Product Change Notification (PCN)

PCN Number: PCN_ConMJTH_20260824 Affected Series: WR-MJ Affected Part Number: 615008138321 PCN Date: 2026-08-24 (YYYY-MM-DD) Effective Date: 2026-11-24 (YYYY-MM-DD)	Change Category: ☐ Equipment/Location ☒ General Data ☐ Material ☐ Process ☐ Product Design ☐ Shipping/Packaging ☐ Supplier ☐ Software
Contact: Product Management Phone: +49 (0) 7942 - 945 5001 Fax: +49 (0) 7942 - 945 5179 E-Mail: pcn.eican@we-online.com	Datasheet Change: ☒ Yes ☐ No Attachment: ☐ Yes ☒ No

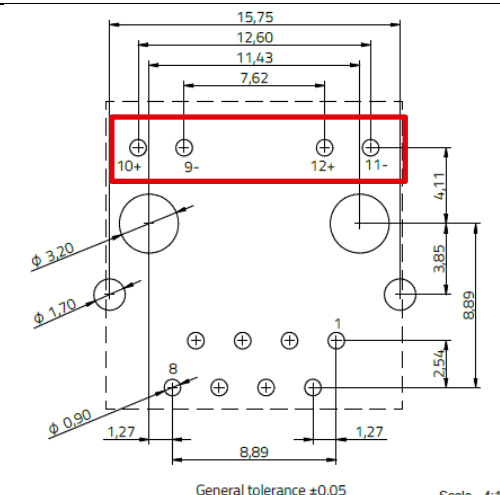
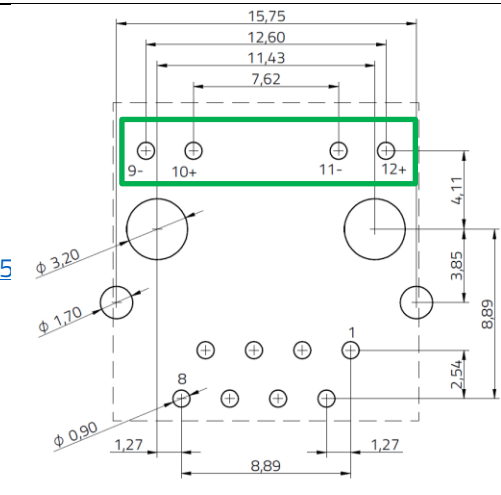
As a datasheet information amendment, Würth Elektronik eiSos is correcting the LED pin schematic error in the recommended hole pattern that was inserted by mistake during the latest datasheet update.

This is a datasheet correction only. There will be no change in form, fit, function, quality or reliability of the product.
